SHERIDAN KITCHEN REMODEL
PROPOSED PLANS
SCALE 1/2" = 1'-0"

REVISION NOTES: 2-03-09

PROPOSED KITCHEN-LAUNDRY-1/2 BATH OVERVIEW

DRAWING DESCRIPTION:
PROPOSED KITCHEN-LAUNDRY PLANS
PROJECT DESCRIPTION: KITCHEN REMODELING
FIRST FLOOR KITCHEN AND BATH REMODEL

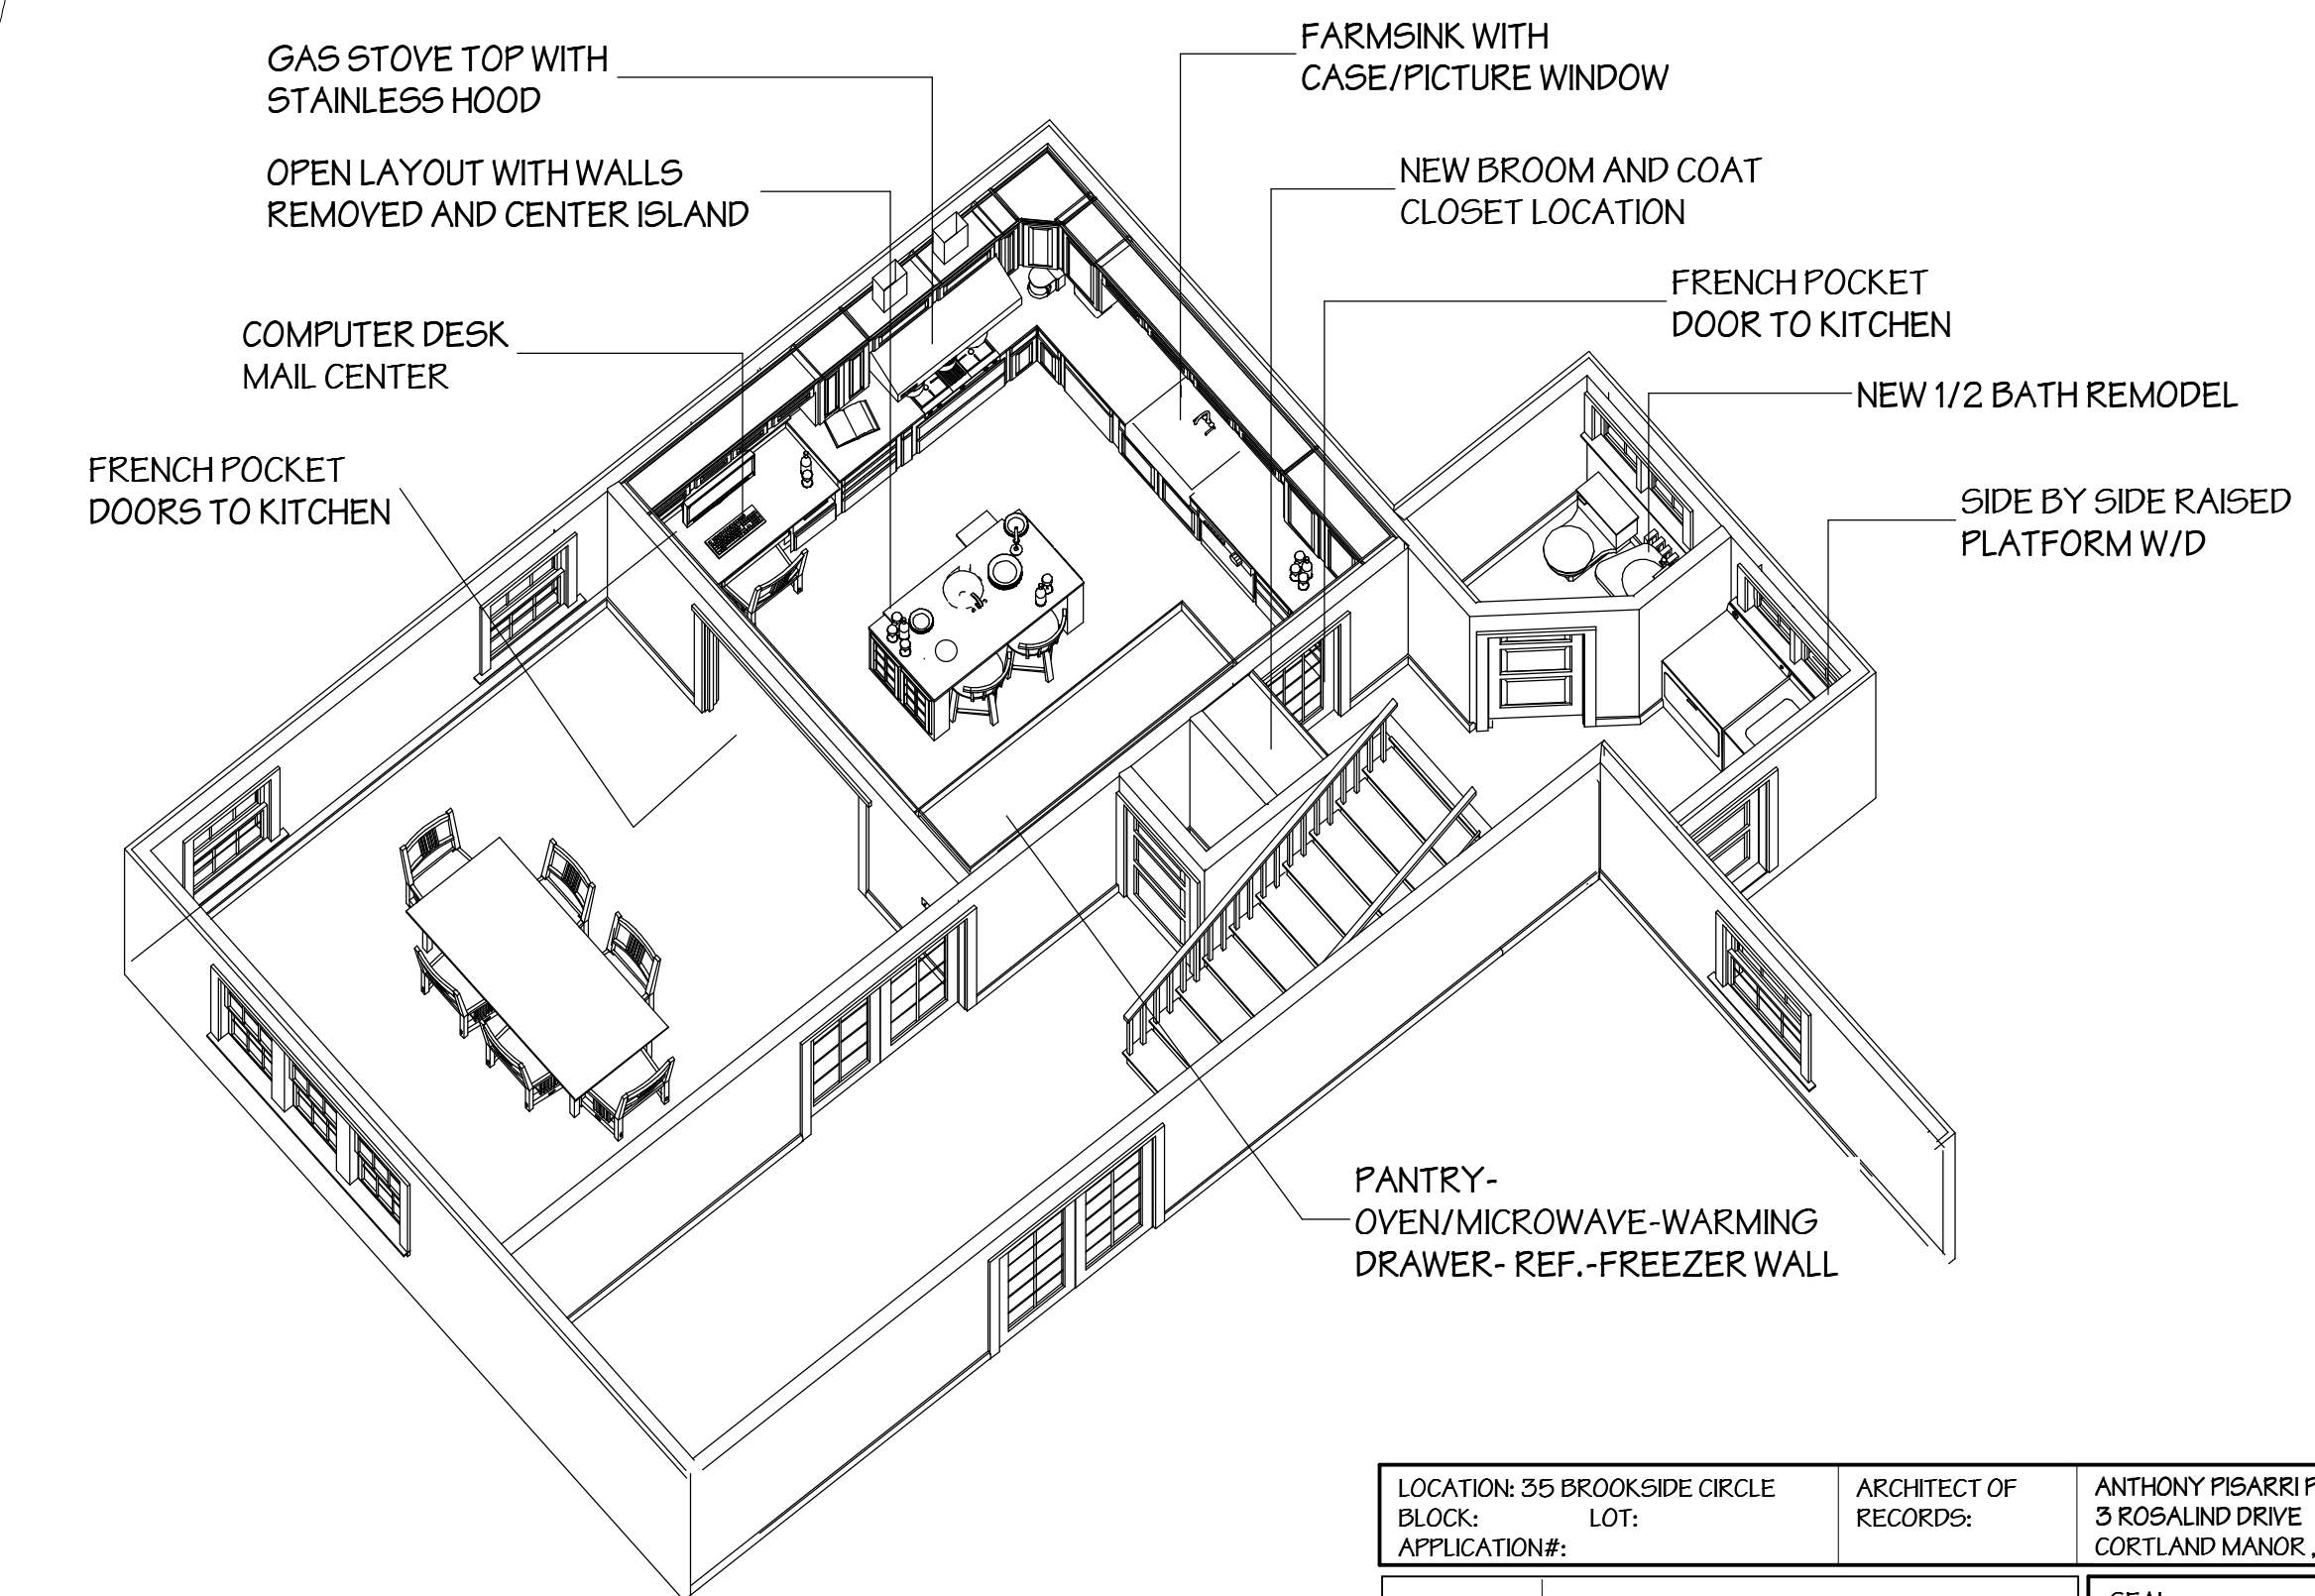
INSULATION DETAIL UPDATE:

THE FOAM INSULATION WHICH WASN'T SHOWN ON THE ORIGINAL PLAN IS CALLED TOUCH N' SEAL. THE "R" VALUE OF THIS PRODUCT IS 7.12 PER/ INCH. THE CONTRACTOR PLACES APPROX. 2-1/2" OF FOAM IN THE CAVITY WALL TO GET AN "R" VALUE OF 17.8 +/- IT IS NOT REQUIRED THAT THE WALL CAVITY SPACE BE COMPLETELY FILLED

DOOR HEADER SIZE UPDATE:

THE HEADER OVER THE SINGLE 2668 POCKET DOOR IS (2) 1-3/4" X 11-1/2" LVL WHICH ONLY SUPPORTS THE STAIR LANDING ABOVE THIS HEADER IS MORE THAN ADEQUATE TO CARRY THE LOAD. NO BEARING OF THE (2) LVL HEADER IS ON THE DOOR FRAME OR THE DOOR WOULDN'T OPERATE PROPERLY
